MFN 10-044 Supplement 1 Revision 2

Docket No. 52-010

Subject: Revised Response (Revision 2) to NRC Request for Additional Information Letter No. 411 Related to ESBWR Design Certification Application – Engineered Safety Features – RAI Number 6.2-202 Supplement 1

Revised Response (Revision 2) to NRC Request for Additional Information Letter No. 411 Related to ESBWR Design Certification Application

Figure 6.2-202 M1

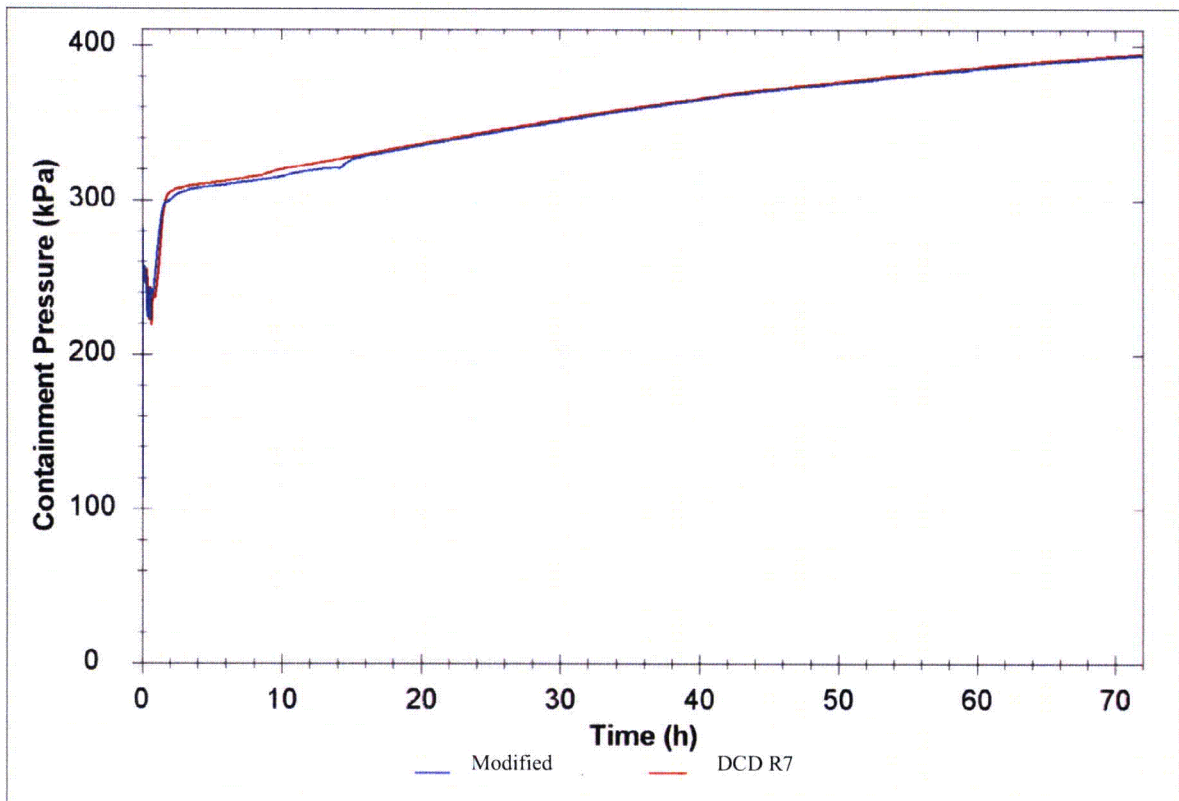
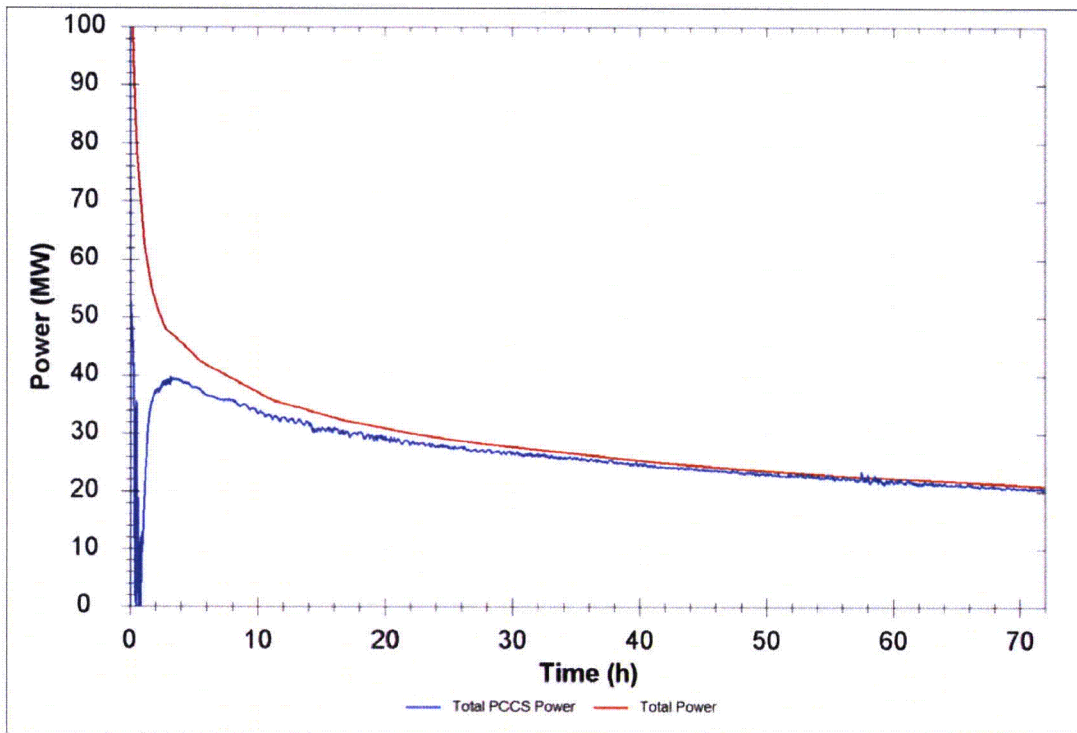
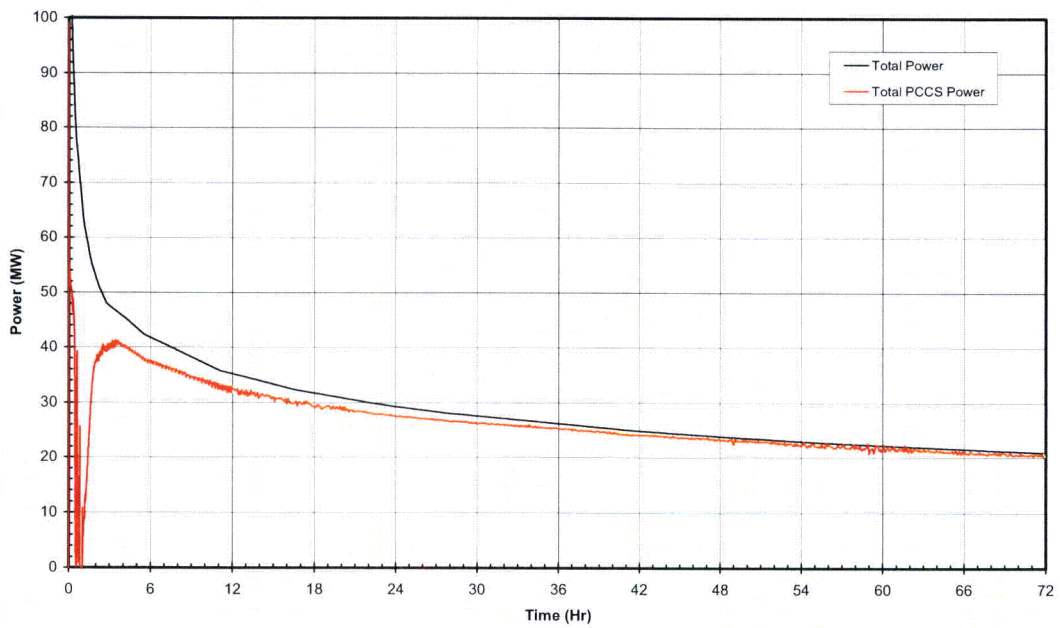
M.2

The results of the TRACG analysis that includes the change in tube material, number of tubes, tube thickness and tube inner diameter is presented in Figures 6.2-202 M1 and 6.2-202 M2. Figure 6.2-202 M1 presents the containment pressure response for the updated TRACG analysis vs. the containment pressure for the TRACG analysis in the DCD Tier 2 R7 Figure 6.2-14j1. They are approximately the same and the modified analysis has a slightly lower maximum pressure than the DCD Rev 7 analysis. Figure 6.2-202 M2 presents the PCCS power for the updated TRACG analysis. The PCCS power is similar to the PCCS power presented in the DCD Tier 2 R7 Figure 6.2-14i1 (Figure 6.2-202 M3). The difference in the curves in each of these figures is due to uncondensed steam flowing to the wetwell from the drywell in the early blow down and from the PCCS in the long term. The figures show that the difference between the decay heat and PCC power in the LOCA transient is similar for the DCD Rev 7 and modified design.

As seen in Figure 6.2-202 M1, the changes to the PCCS did not affect the TRACG results for containment pressure. The updated analysis shows that the long term LOCA response remains approximately the same as the previous analysis. This is because the wall thermal conductivity decrease offset the surface area increase. The PCCS continues to operate below its 100% steam capacity rating (47 MW total rated capacity for 6 PCCS condensers) in the long term (6-72 hour period) DBA LOCA as indicated by the Total PCCS Power in Figure 6.2-202 M2. It is operating below its 47 MW (7.8 MW per unit) capacity during the DBA LOCA. The integral PANDA tests included all of the

features required for an integral system simulation for a long term LOCA response. Figure 6.2-202 M2 shows the PCCS power, which in comparison to the DCD R7 PCCS power (Figure 6.2-202 M3) is similar, and therefore, the integral long term LOCA response of the system will remain the same and PANDA tests are still applicable..
